**Re: In the Matter of the Application of The York Water Company, Under Sections 507, 1102(a)(1) and 1102(a)(3) of the Public Utility Code, for approval of the right of The York Water Company to (1) enter into a municipal contract to acquire certain public wastewater facilities from Letterkenny Township Municipal Authority; and (2) begin to offer or furnish wastewater service to the public in a portion of Letterkenny Township, Franklin County, Pennsylvania
Docket No. A-2020-3019424**

Bureau of Technical Utility Services Water/Wastewater Division
Data Request Set 2

Application of The York Water Company - Wastewater to Acquire the Letterkenny Township
Municipal Authority Wastewater System at Docket No. A-2020-3019424

LETTERKENNY TOWNSHIP MUNICIPAL AUTHORITY
CERTIFICATED TERRITORY MAP - REVISED PER TUS A-25

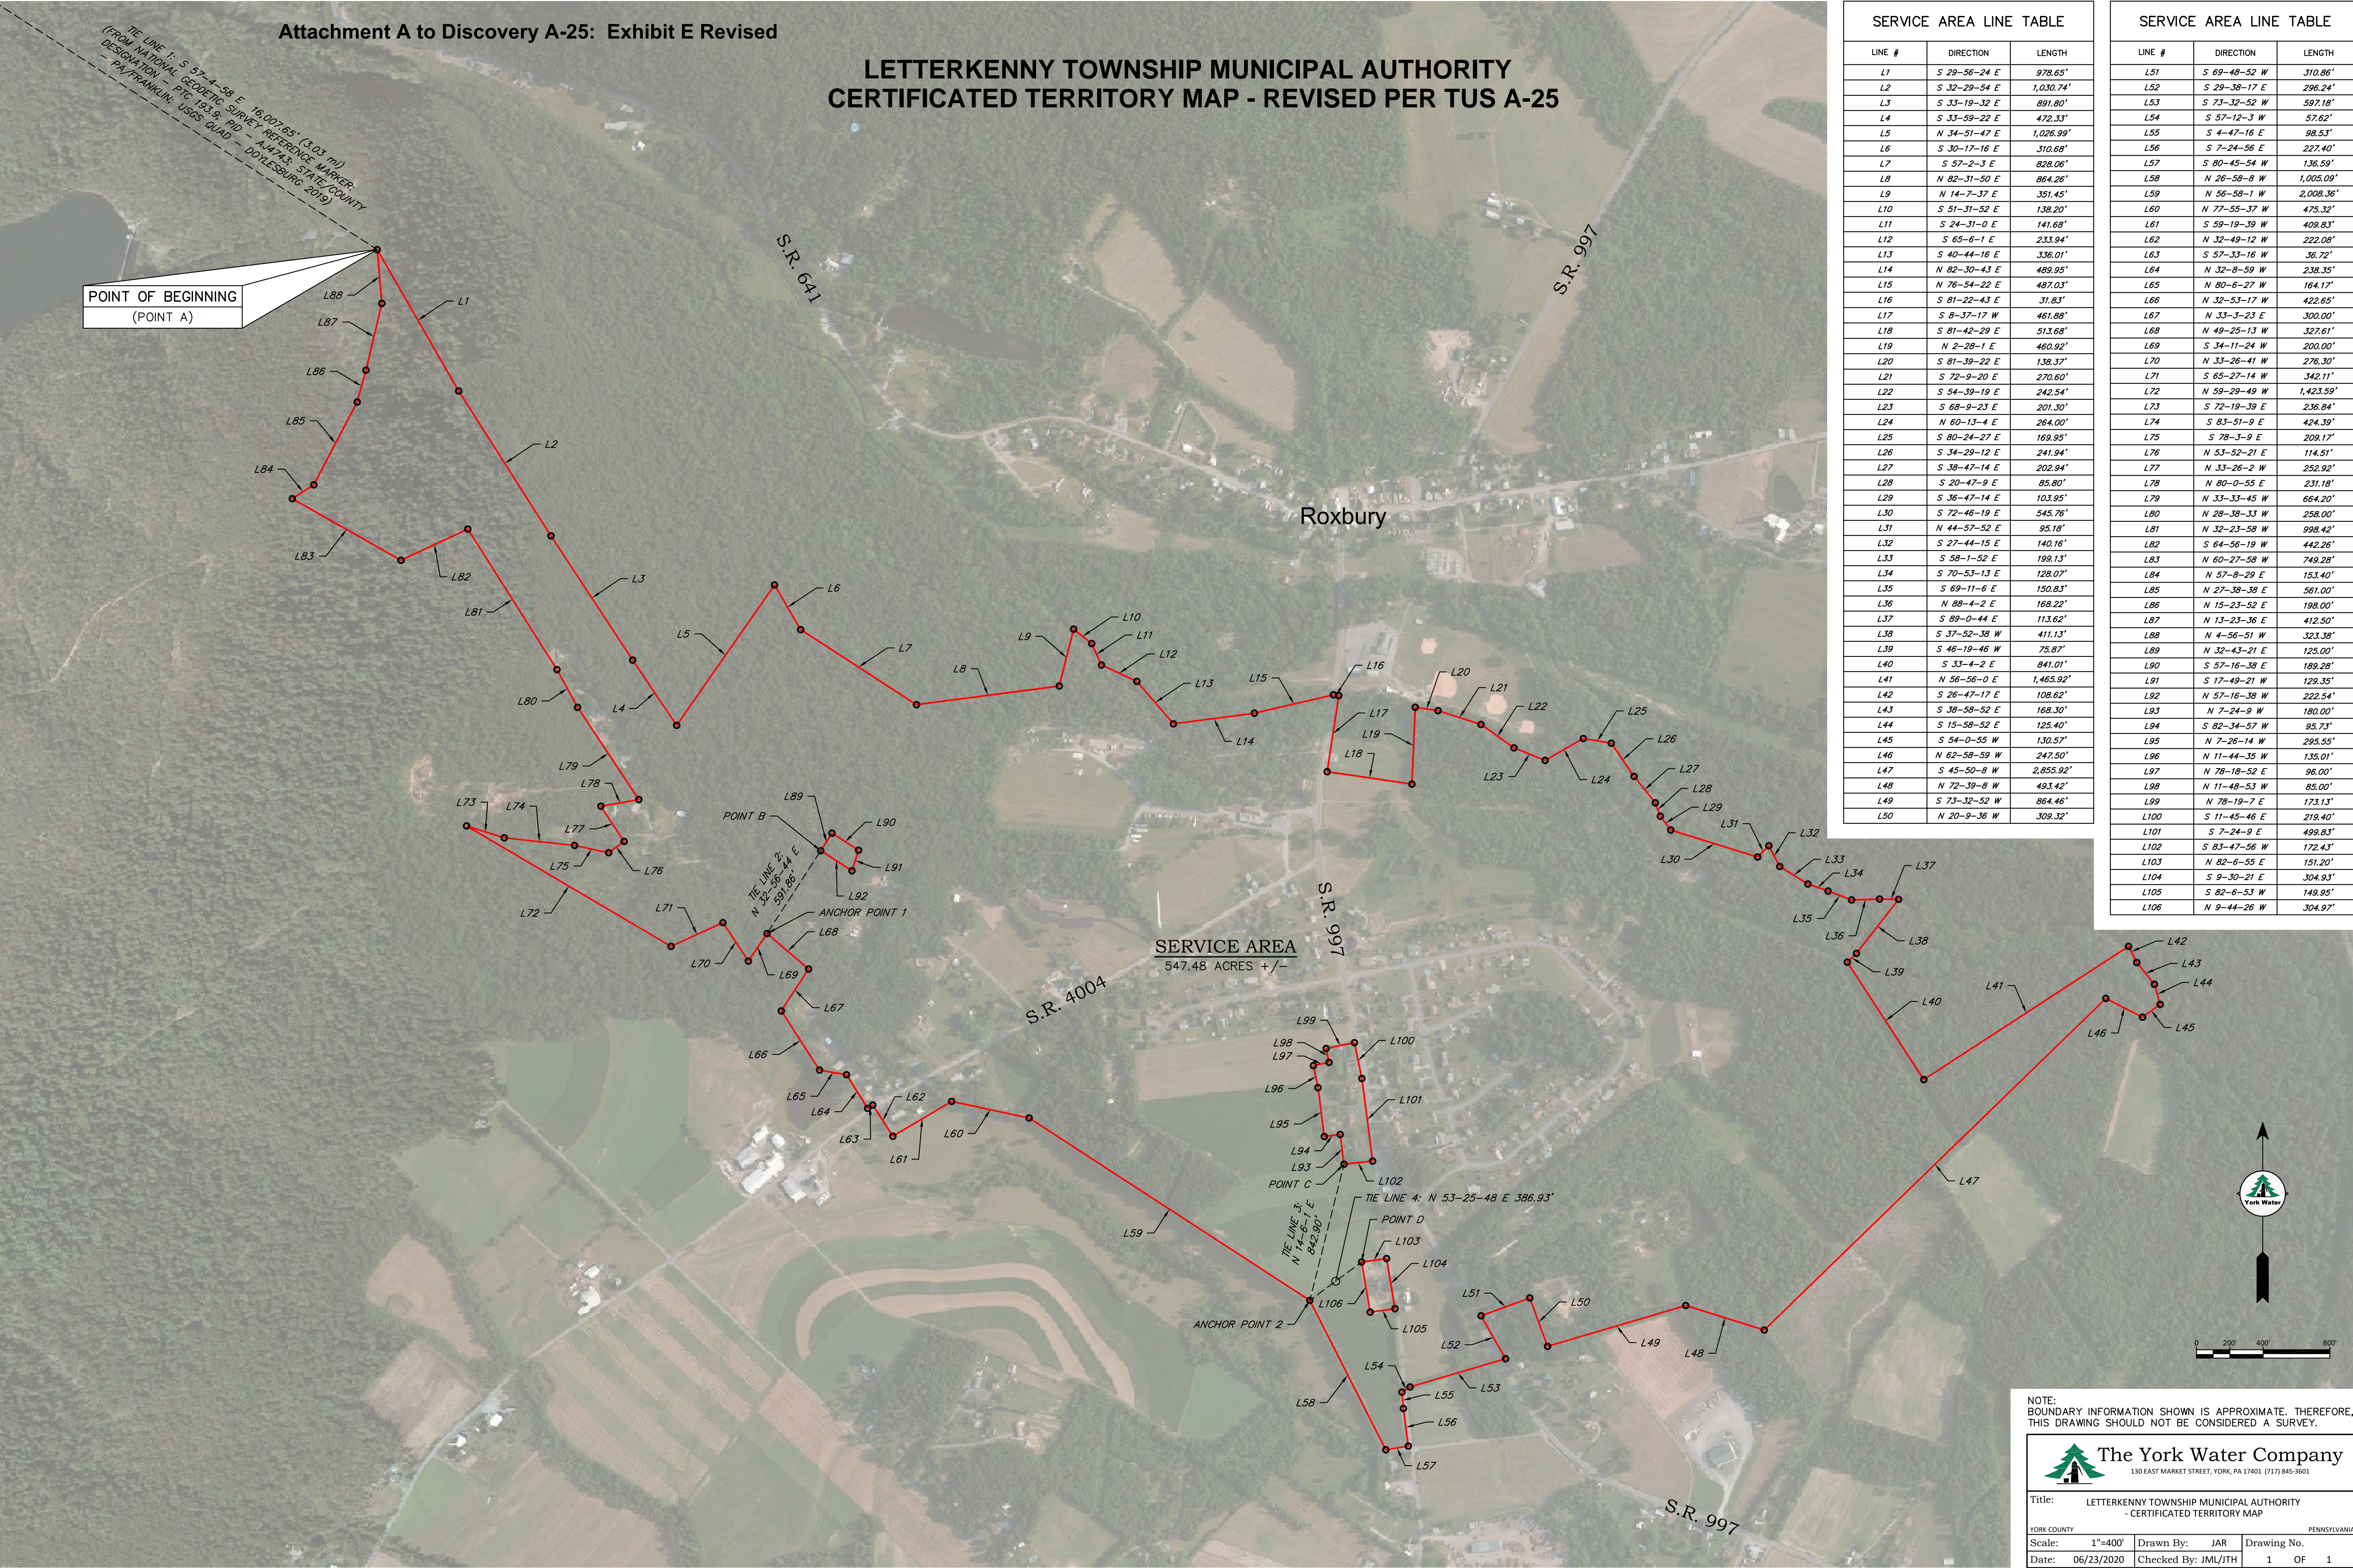
York-WW identified several properties on the list of properties included in the response to Data Request A-15 as “Buffer Properties” and provided comments regarding several other properties surrounding the area identified as “Proposed Certificated Area – LTMA” on the map provided in supplemental information as Attachment A-15a. Please revise the Application’s Exhibits E and E-1 to reflect a requested service territory that excludes properties not currently served by LTMA, not previously approved by LTMA to receive service, and which do not contain frontage along an existing LTMA wastewater main and quantify the revised service territory area.

Revised Exhibits E and E-1 are attached as Attachment A and Attachment B, respectively. The revised service territory is approximately 547 acres.
